## CITY OF WEST ST. PAUL

### ENVIRONMENTAL COMMITTEE MEETING WEDNESDAY, OCTOBER 5, 2016 AT 6:00PM MUNICIPAL CENTER ADMINISTRATION CONFERENCE ROOM

CASE #16-14 – Site Plan review for 1994 Robert St.

Review Landscape Plan and provide recommendations to the Planning Commission/Council

**LANDSCAPE PLAN**

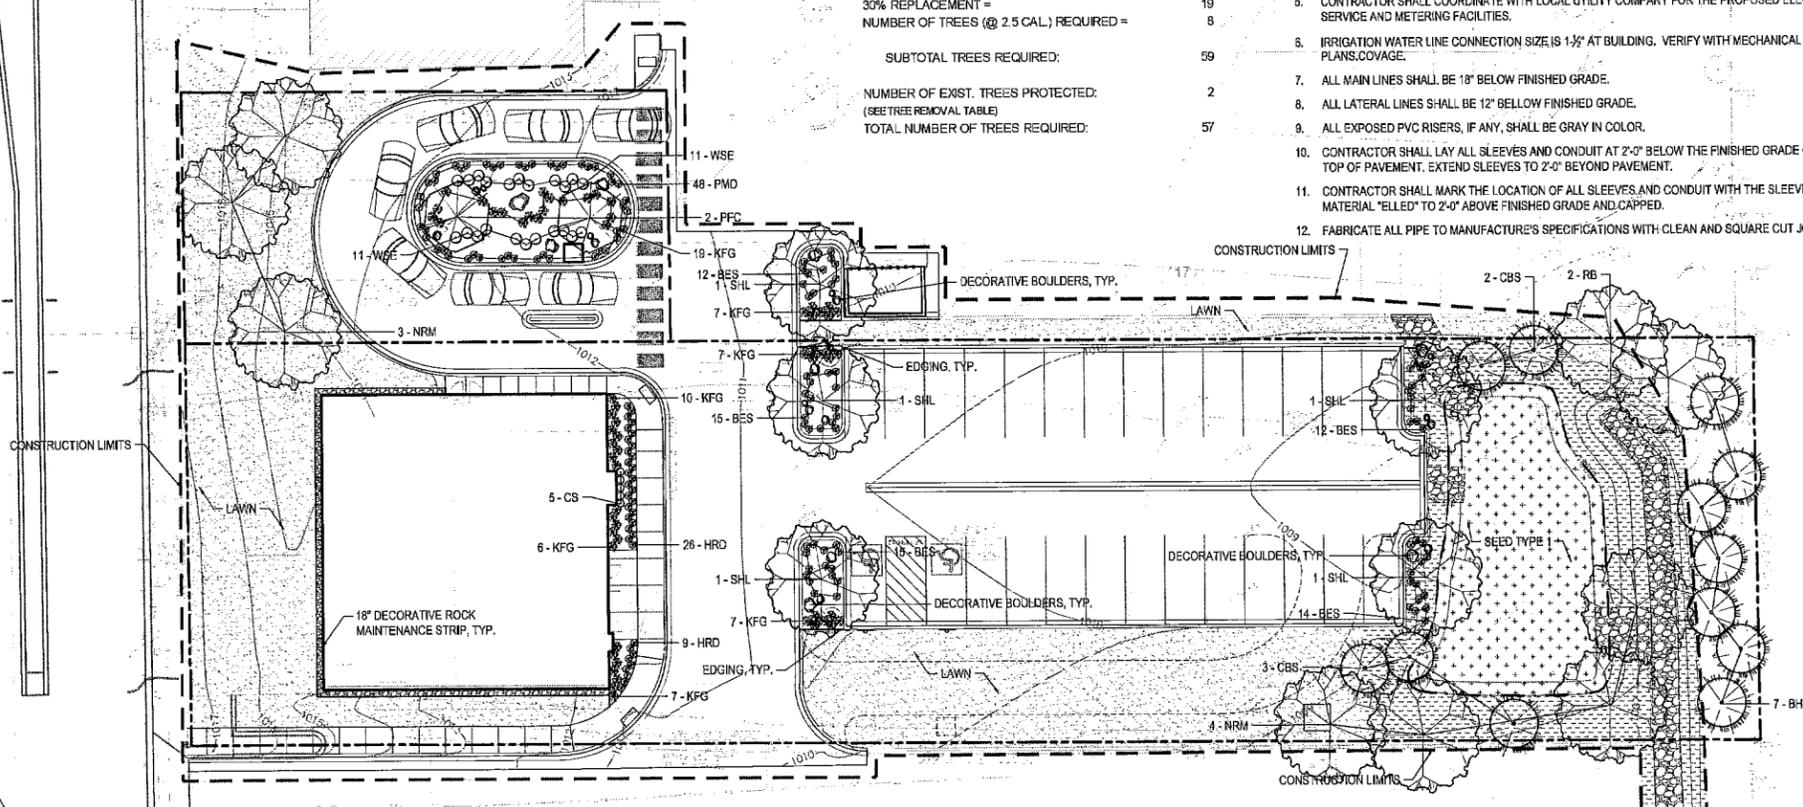
Based on the exterior linear feet of the newly created property, code requires a total of 51 trees on-site (1 tree per 20 lineal ft. of property). The applicant is proposing a total of 15 deciduous trees at 2.5 caliper inches, 2 ornamental trees at 1.5 caliber inches, and 12 evergreen trees at 6 ft. in height for a total of 29 trees.

The Robert Street project includes 3 trees evenly spaced directly behind the sidewalk (not shown on the plan). As a result, Staff is recommending that the proposed tree located closest to the front property line be removed (proposed location of one of the three Robert St. project trees). In addition, since the proposed site plan is well short of the required 51 trees, Staff also recommends additional deciduous trees be added directly adjacent to the southern curb line of the parking lot as well as directly adjacent to the south property line (staying clear of the proposed future ATM drive through lane as shown on the plan). Said trees shall be spaced appropriately per approval of staff. Staff is looking for a recommendation from the EC on whether or not the spacing allows trees in these locations.

In addition to the trees proposed, the plan also includes a total of 241 perennials and grasses as detailed in the plant schedule table at the lower left side of the plan.

With that said, Staff is requesting a recommendation from the Environmental Committee should the committee have recommendations pertaining to planting types and/or locations.
